Finding of Suitability to Transfer for Parcel A (Revision 3)

Hunters Point Shipyard
San Francisco, California

- 1 Revised Responses to Agency Comments on the Draft Finding of Suitability to Transfer for Parcel A, Dated November 6, 1998
- 2 Revised Responses to Agency Comments on the Draft Final Finding of Suitability to Transfer for Parcel A, Dated September 22, 1999

- 3 Responses to Agency and Public Comments on the Finding of Suitability to Transfer for Parcel A, Revision 2, Dated March 26, 2002
- 4 Resolution of the Responses to Agency Comments on the Finding of Suitability to Transfer for Parcel A, Revision 2, Dated August 26, 2002

**FIGURE 4
PARCEL A CERCLA SITES**

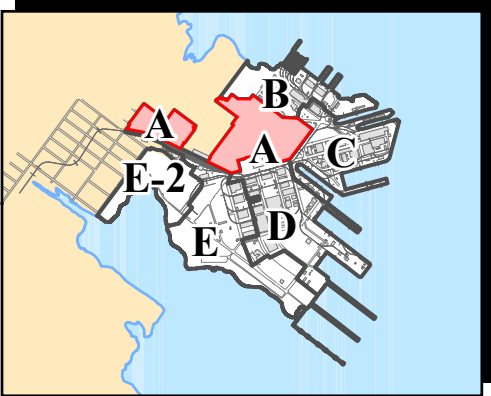
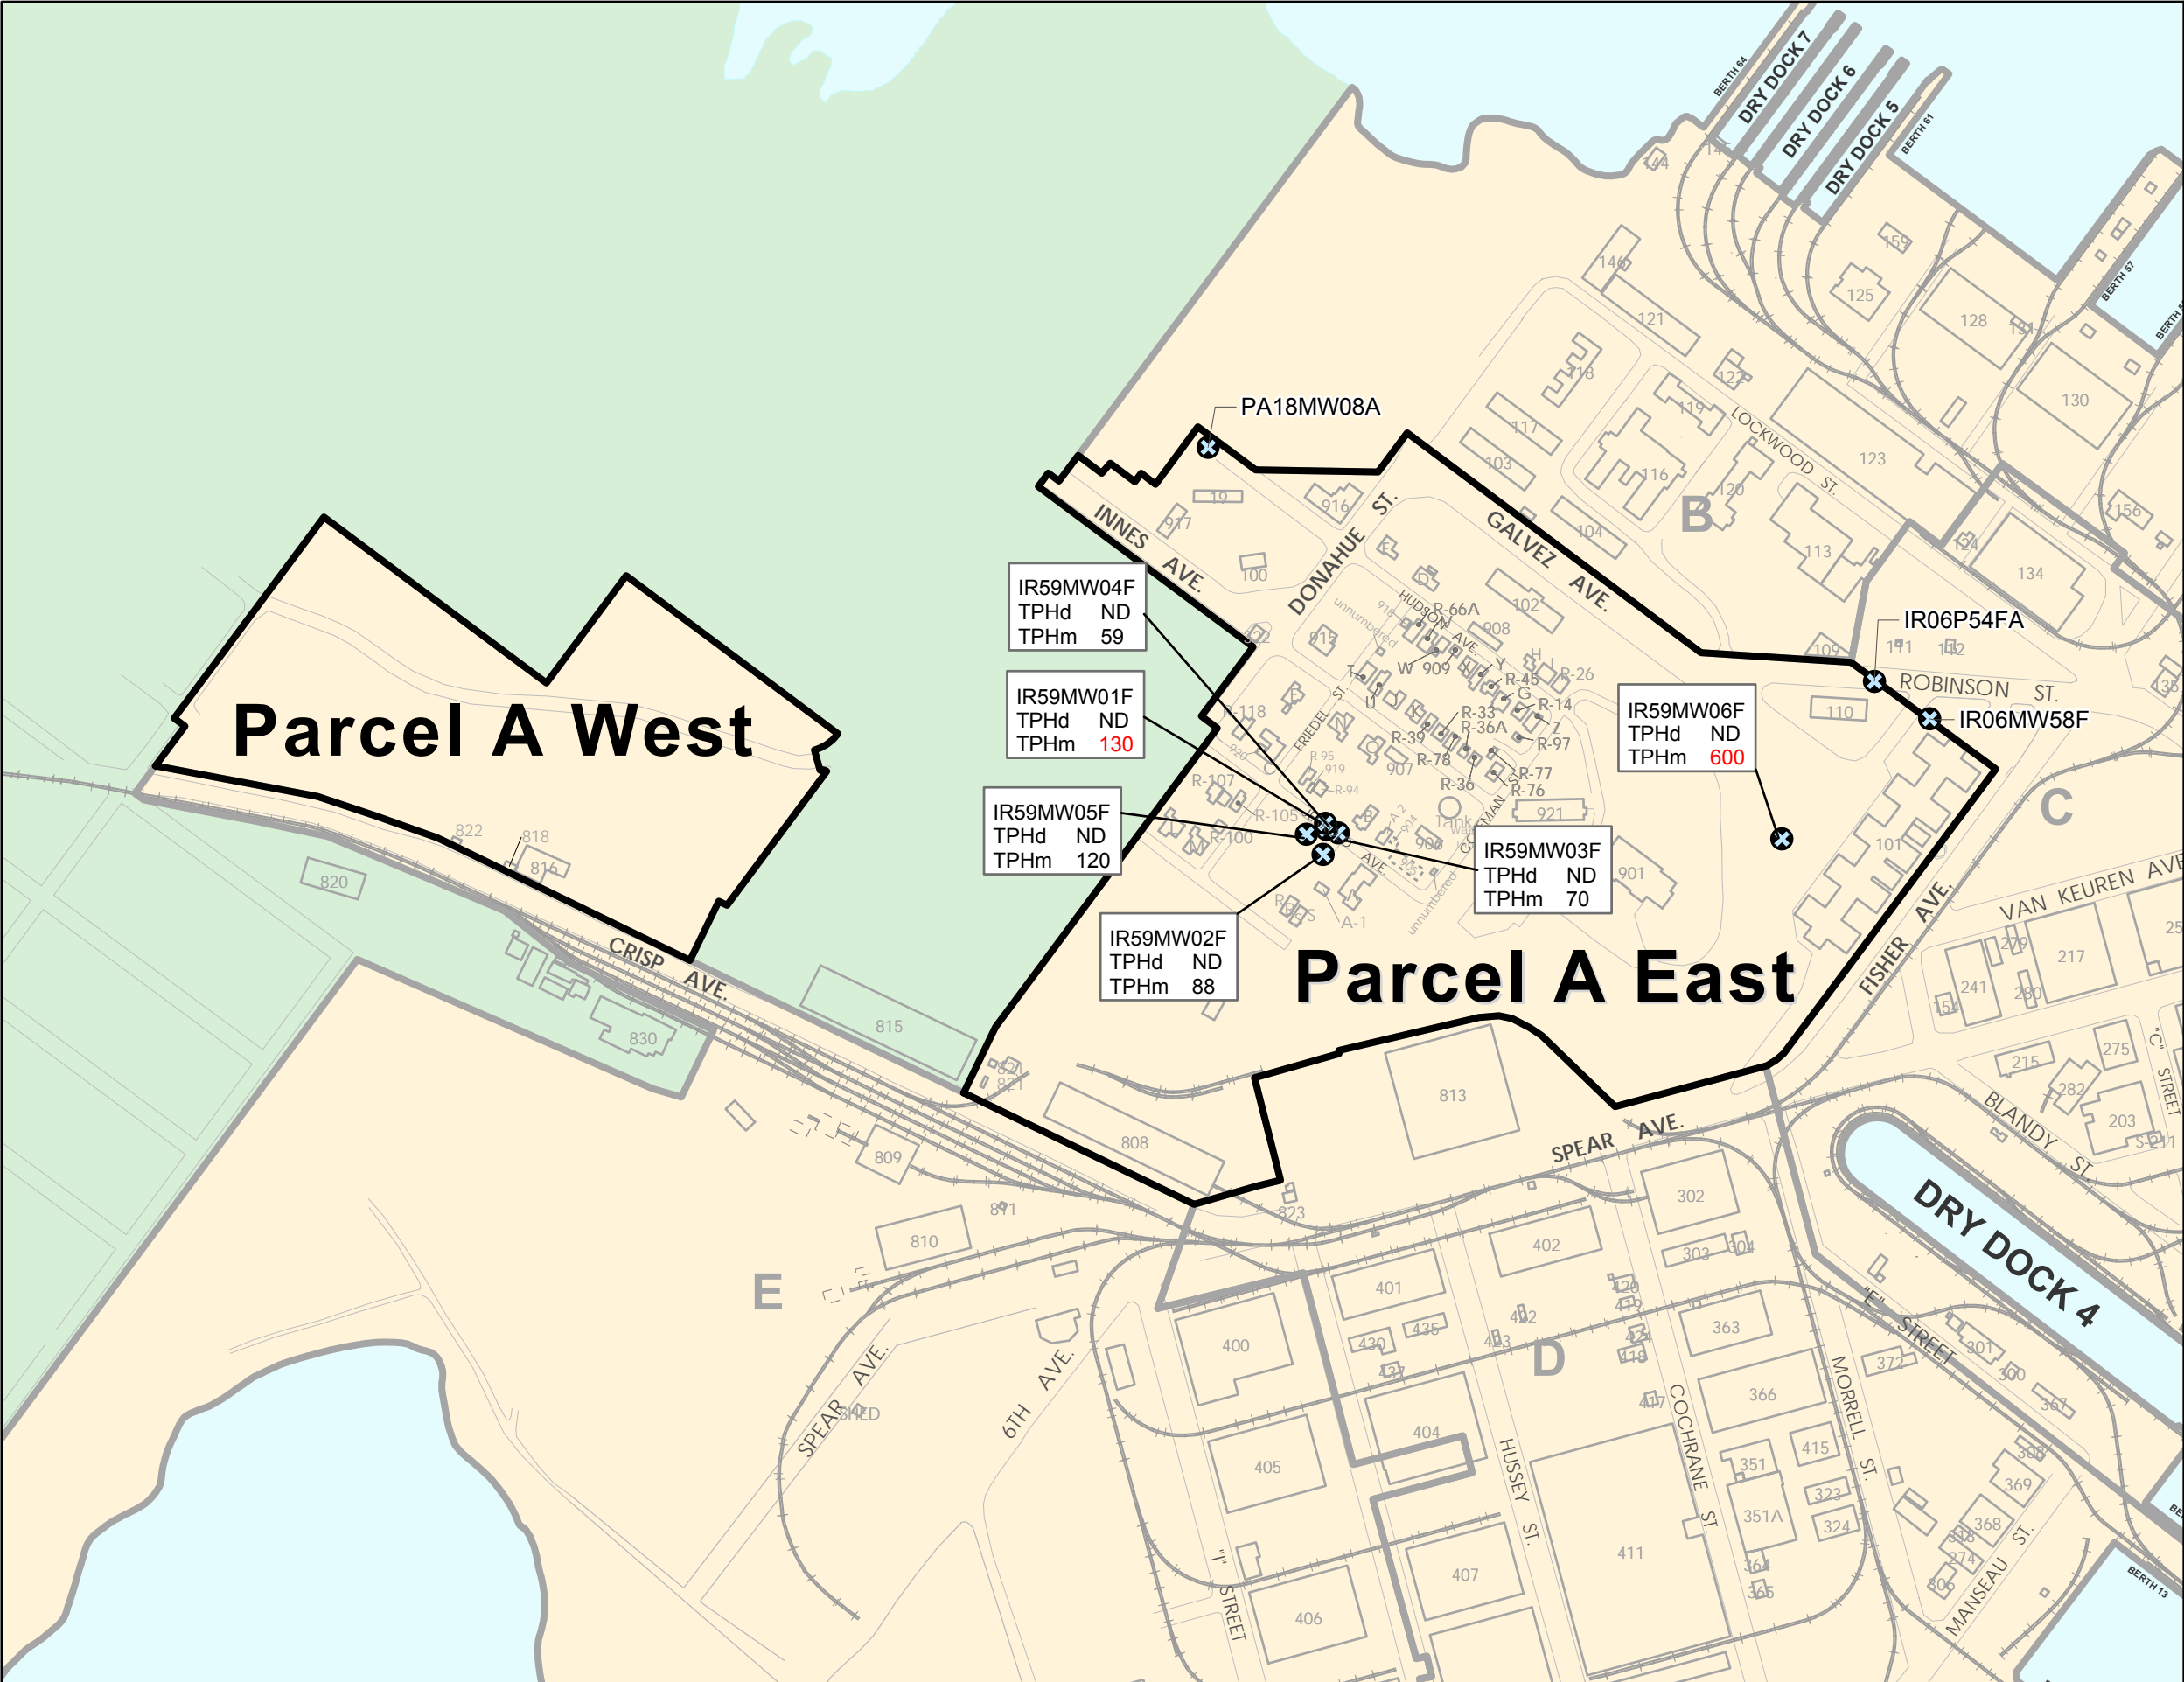
20. Comment: **Figure 4:** Please include the date of the aerial photograph.

Response: The date of the photograph (2000) has been included on [Figure 4](#) of the revised FOST.
